**City of Fairhope
Planning Commission Agenda
5:00 PM
Council Chambers
January 4, 2024**

City of Fairhope Planning Commission

UR 24.01 - Colony Place at Fairhope

Figure 6: As-Builts re-submitted on December 21, 2023.

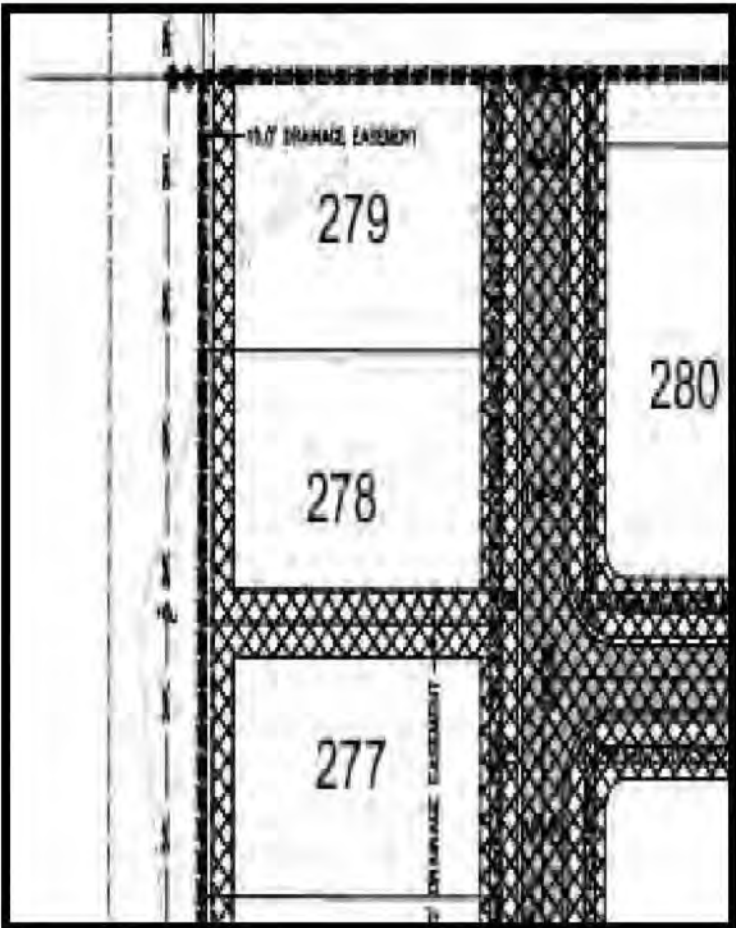
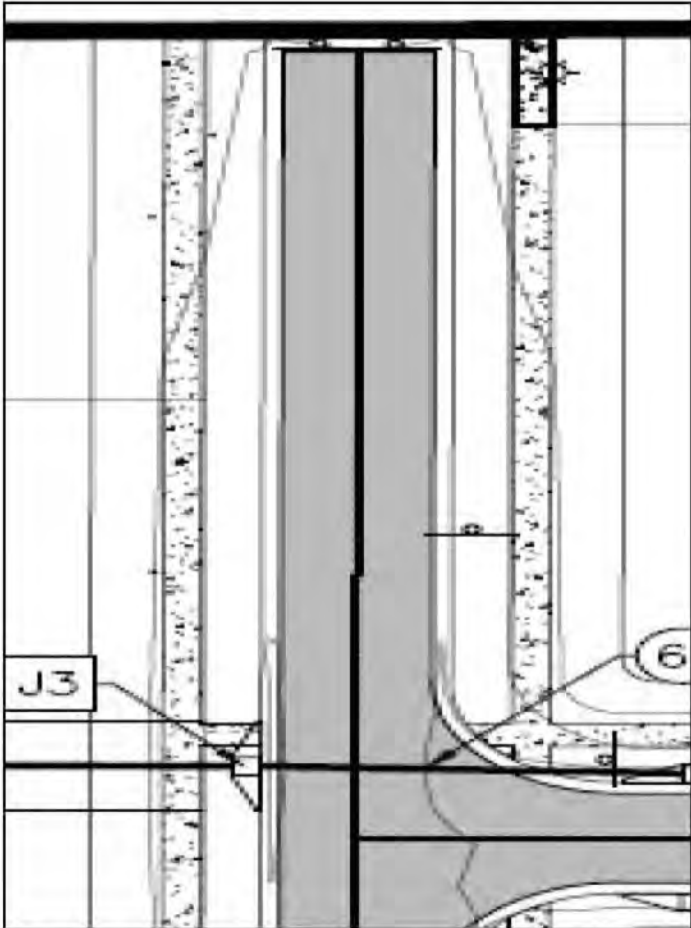
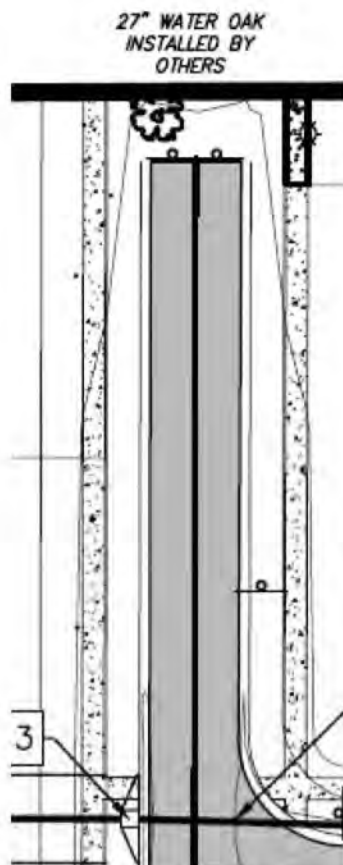
Interior sidewalks are illustrated on the Final Plat. However, the sidewalk at end of Bennington Avenue stops approximately 17' from property line; whereas As-Builts show sidewalks continuing to the property line. The barricade is in the proper location per As-Builts.

December 11 site visit noted a healthy heritage tree within the property boundary and at end of and within the future ROW of Bennington Avenue that was not on the Preliminary Plat, Final Plat, or submitted Landscape Plan. The tree is approximately 27' DBH and is protected. The tree could potentially cause conflict with connecting Bennington Avenue to future development. Applicant has since added the heritage tree to the plans and presented options regarding the tree and future through street.

Review Comment: Install sidewalks to property line at end of Bennington Avenue per As-Builts and plat.

Addendum 12/15/2023: The end of Bennington Avenue between Lot-279 and Lot-280 is currently still under review. The road and sidewalk do not extend as shown on the preliminary drawings and as shown on the As-Builts. The road and sidewalk currently stop approximately 17' short of the property line. A healthy heritage tree, approximately 30" DBH, which is protected also exists that was not shown on the preliminary landscape plan. Hold off on any work including the comment provided on the review letter sent Wednesday regarding extending the sidewalks at the end of Bennington Ave. Provide a proposed solution to address this conflict as part of the resubmittal next week.

The sidewalks shall be extended to the north property line per the submitted Final Plat. That is not optional.

Applicant proposes removing the tree as an option. Normally this would have been reviewed with the original submitted landscape plan in SD 21.36. The heritage tree was not documented in the original submitted landscape plan. However, the grubbing and clearing plan submitted with the Land Disturbance permit application shows the property being cleared to the property line at the end of Bennington Avenue.

As a condition of approval, a resolution to the heritage tree conflict shall be decided by the Planning Commission.

- **Response:** The heritage tree has been added to the plans. In our opinion, we have two options: (1) Remove the tree and leave the roadway as is or extend the roadway to the north property line, or (2) extend the sidewalk to the north property line and leave the roadway as is. We think the most logical solution is to keep it as is as it matches the plans.

PP2

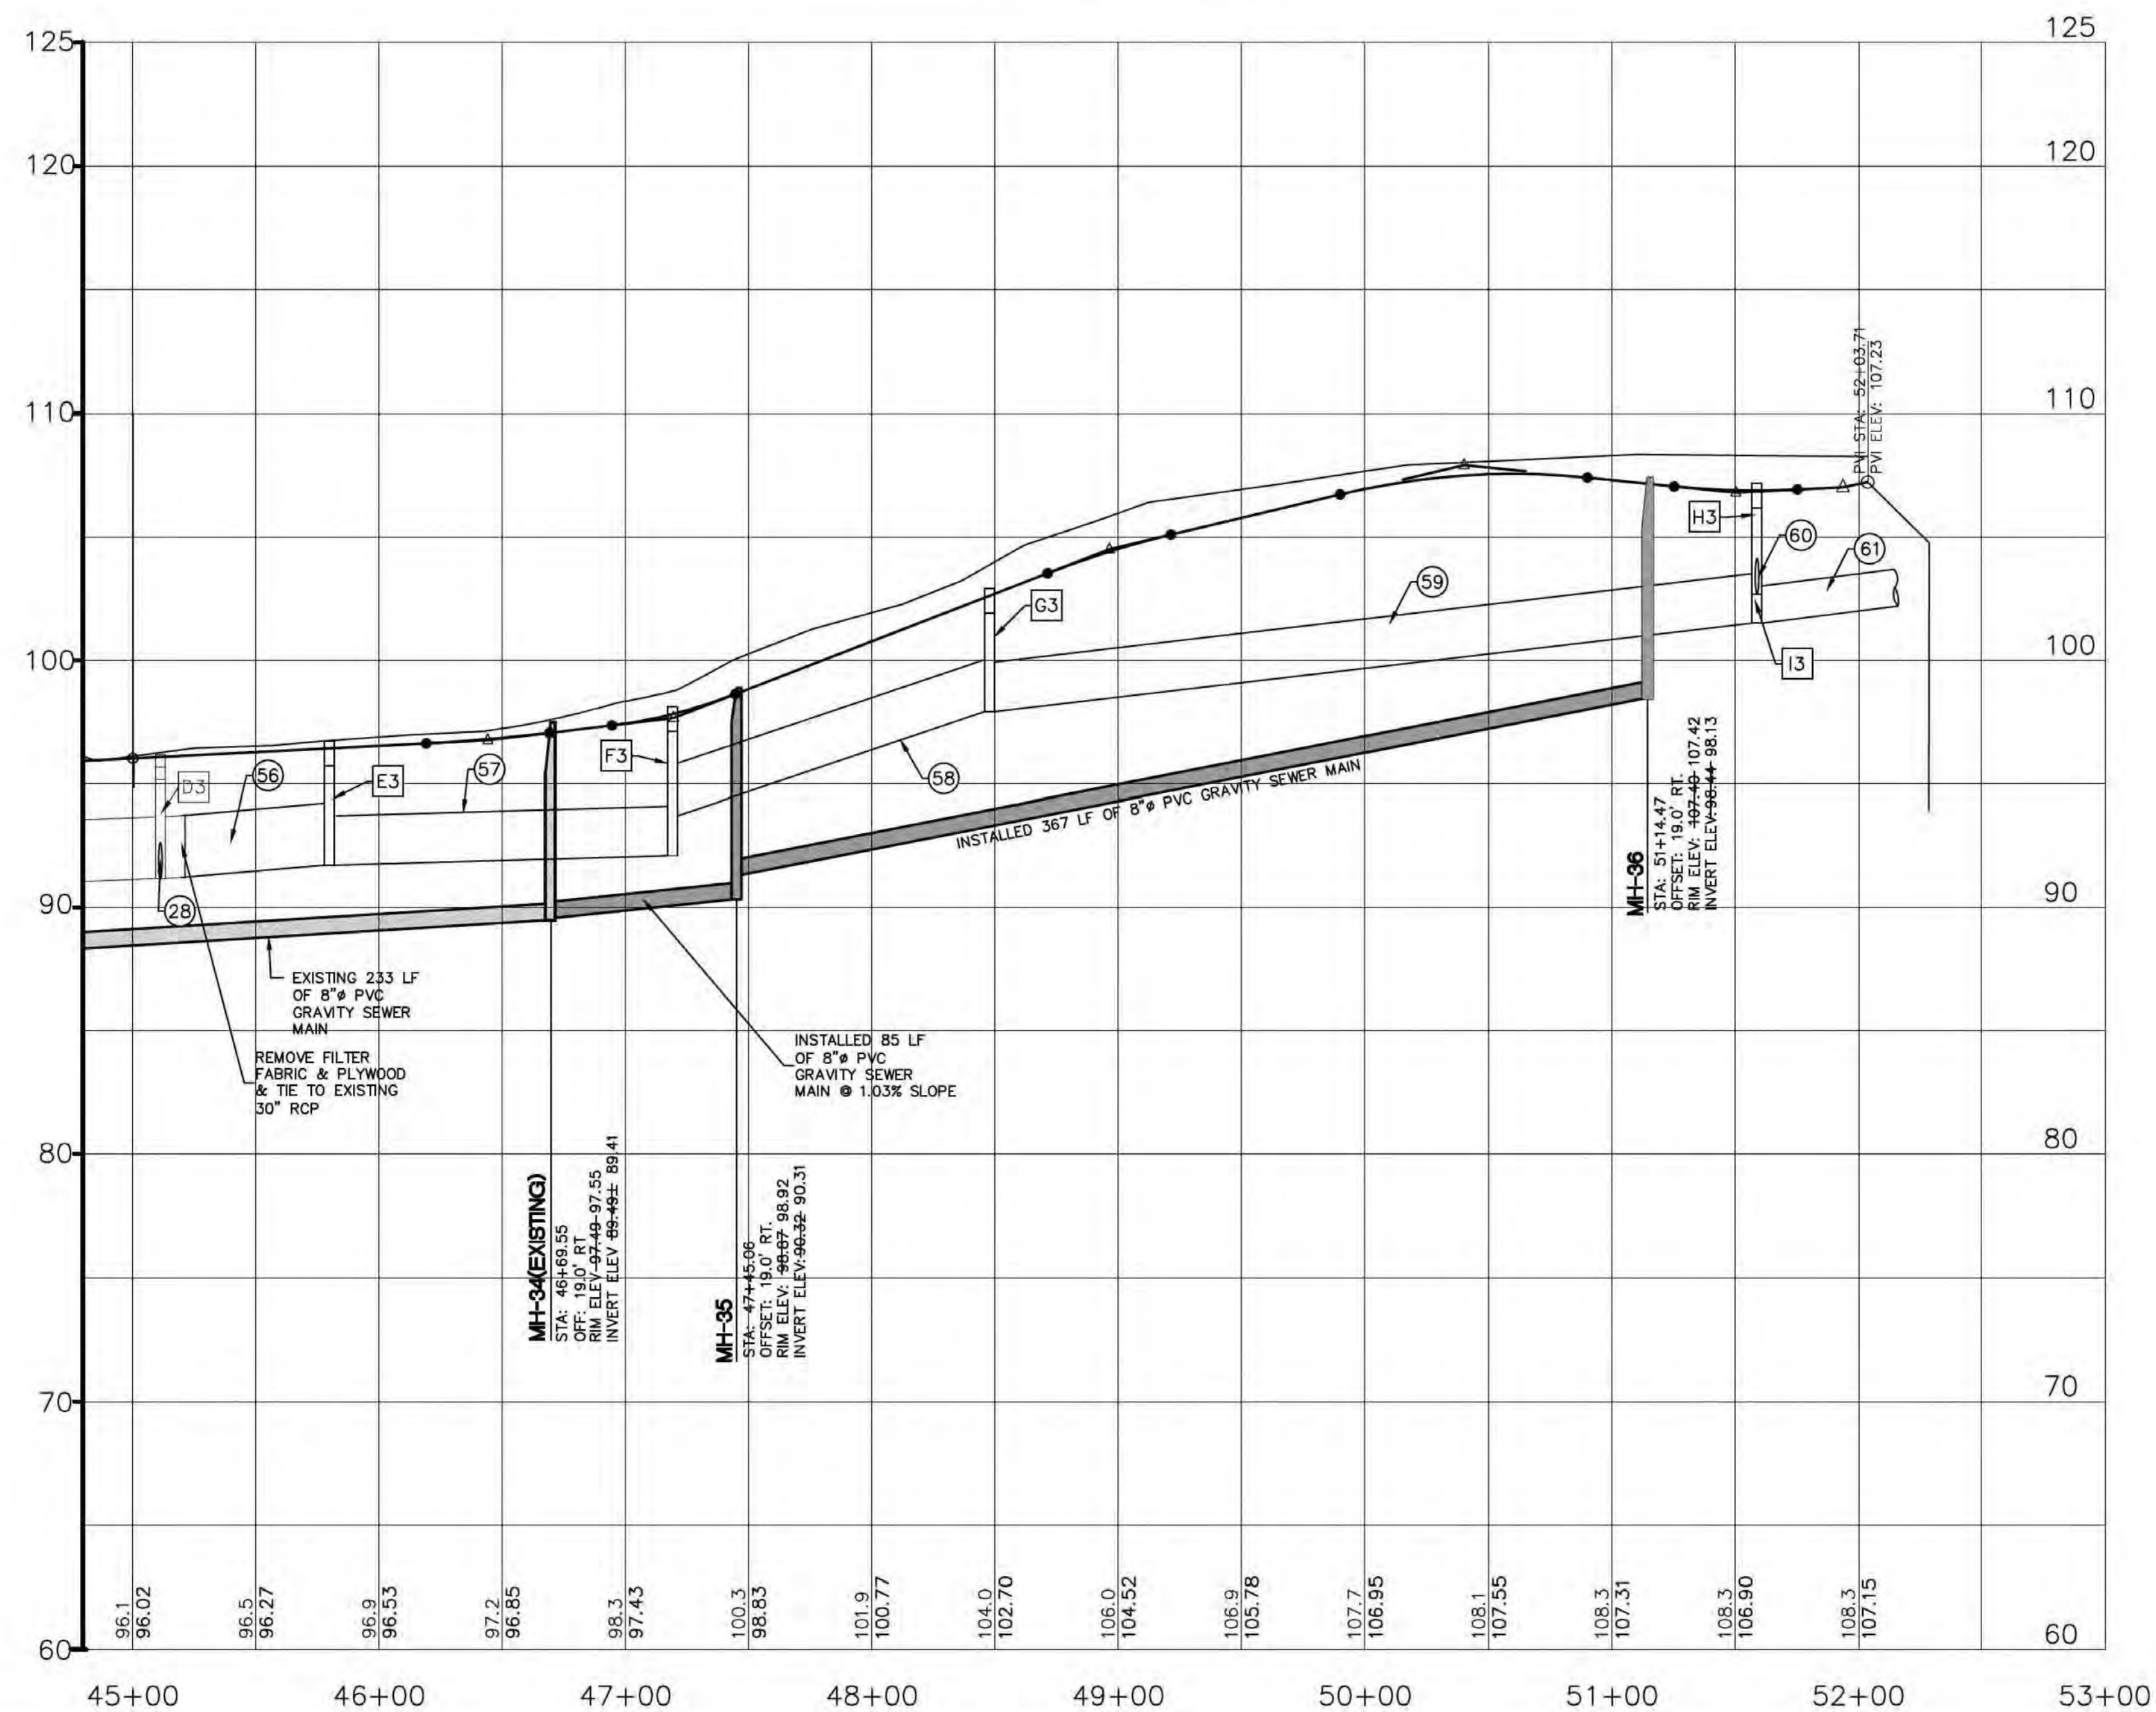
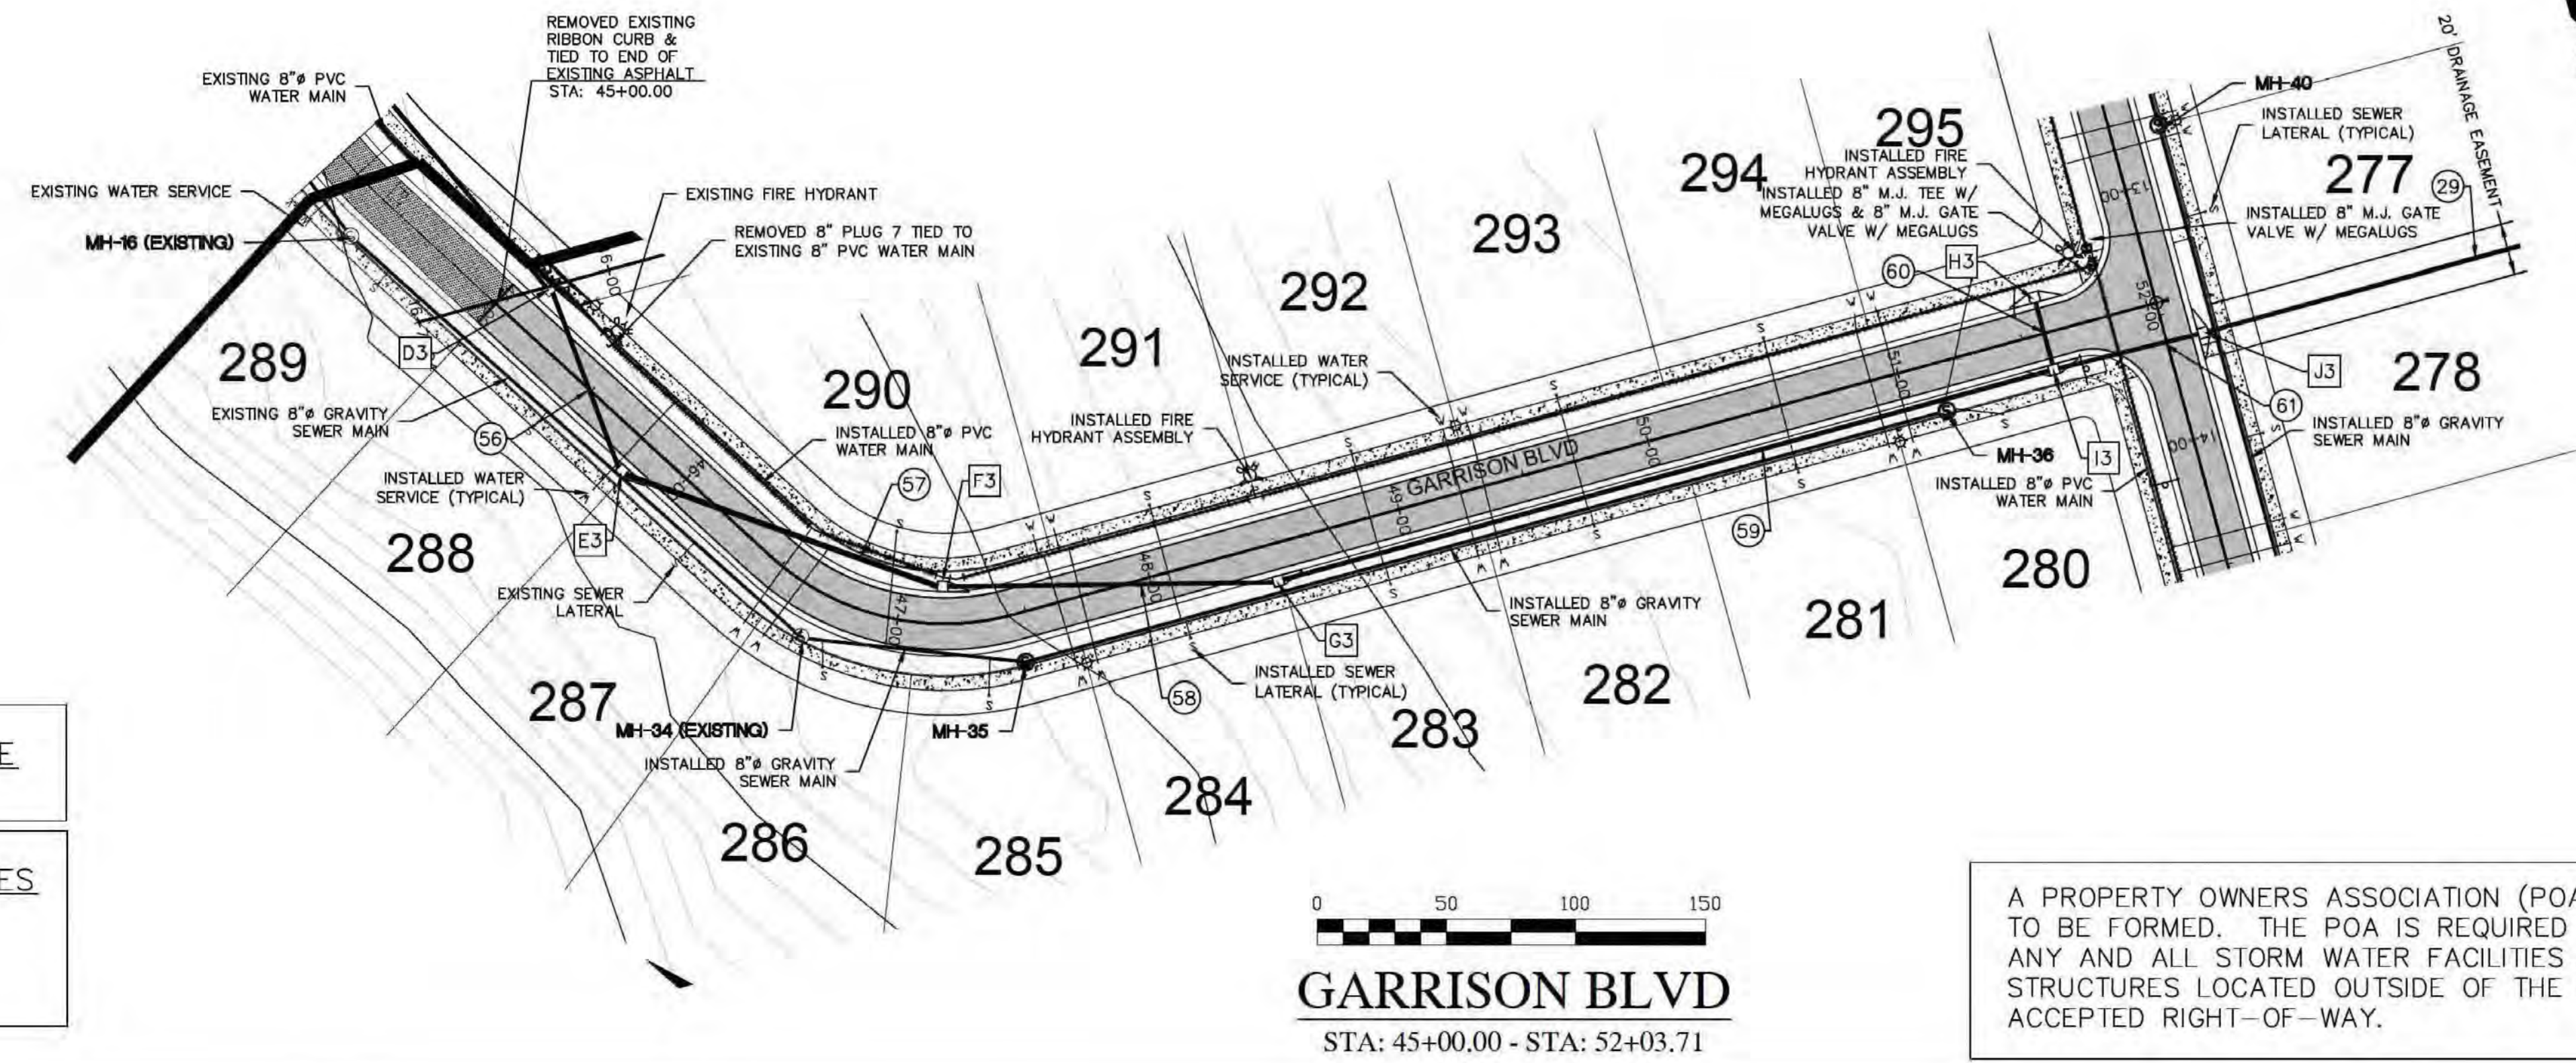
10. Other punch list items per David Thomas, ROW Inspector in letter dated December 11, 2023. *See attached.*
11. Please correct and make consistent easement measurements on all the hard copies and electronic submissions. For example, As-Builts in CitizenServe have a 750 ft Alabama Power Easement and a 2000 ft drainage easement, among other mis-measured easements. It appears that Sheet PP2 is the offender.

- o **Response:** All punch list items have been addressed.
11. **Review Comment:** Please correct and make consistent easement measurements on all the hard copies and electronic submissions. For example, As-Built in CitizenServe have a 750 ft Alabama Power Easement and a 2000 ft drainage easement, among other mis-measured easements. It appears that Sheet PP2 is the offender.

- o **Response:** Easements have been corrected on the offending sheet.
12. **Review Comment:** Please check and add tree at the end of Bennington Avenue to the plat if it is determined it is within the property line.

S.E. Civil Engineering & Surveying 9909 Windmill Road Fairburn, AL 36525 Phone: 205.966.6666	
DATE	REVISION
The Flats at East Bay 9716 Twin Beech Road (County Hwy 44) Fairhope, Alabama	
JOB No. 20200572	DATE 11/20/23
DRAWN DAK	SCALE 1"=30'
SHEET C01.1

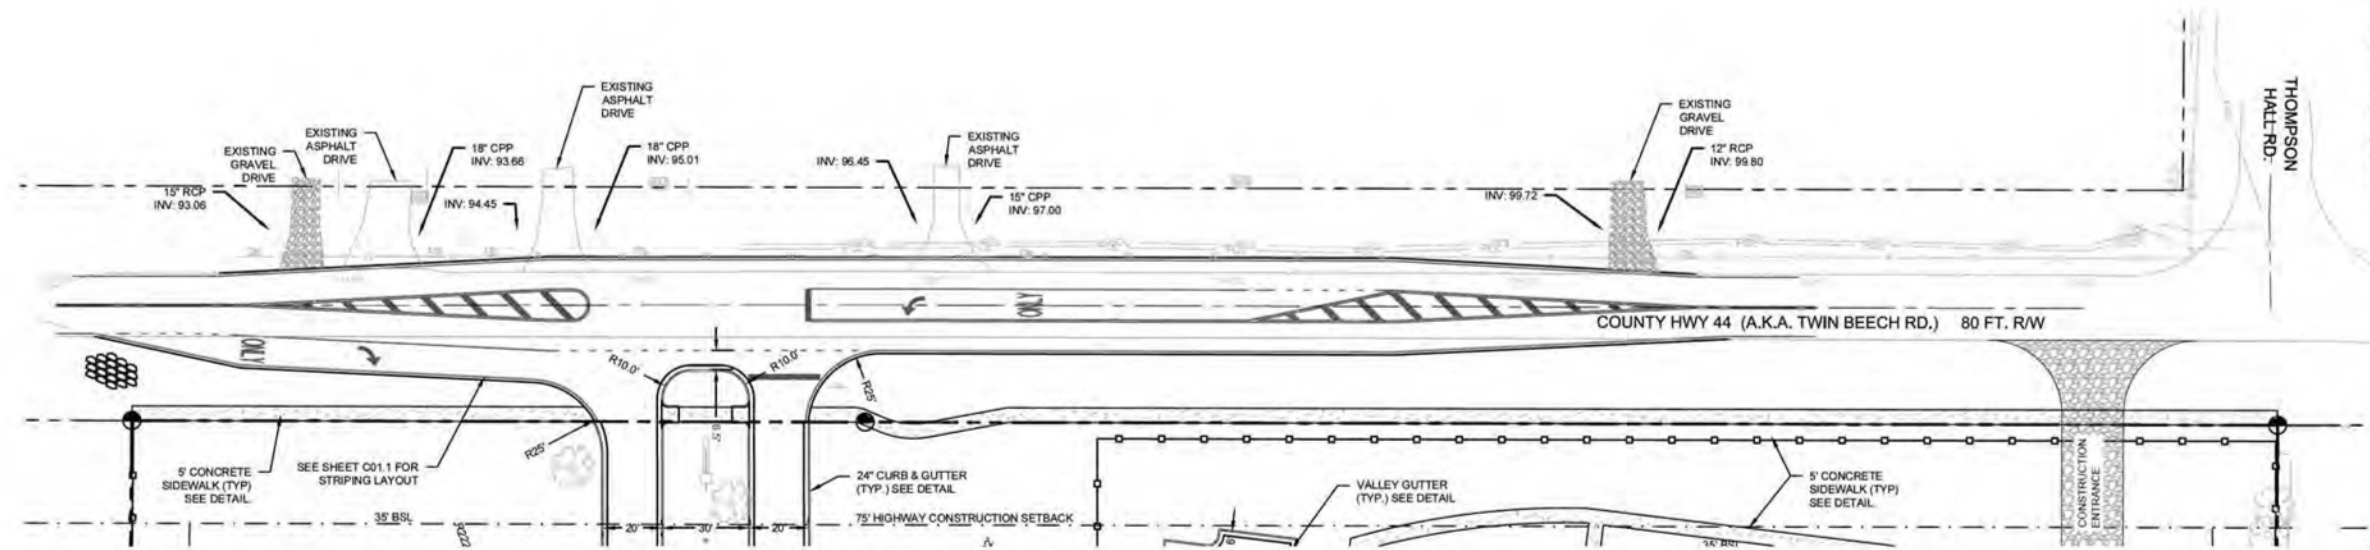
1. Replace the 24inch stop sign with a 36inch stop sign as shown on Sheet C01.1 of the construction plans.
2. Re-grade the ditch and adjacent shoulder slopes around the sloped paved headwall in the right-of-way just west of the entrance. Once all has been properly graded apply permanent vegetation (sod) on all exposed soils.
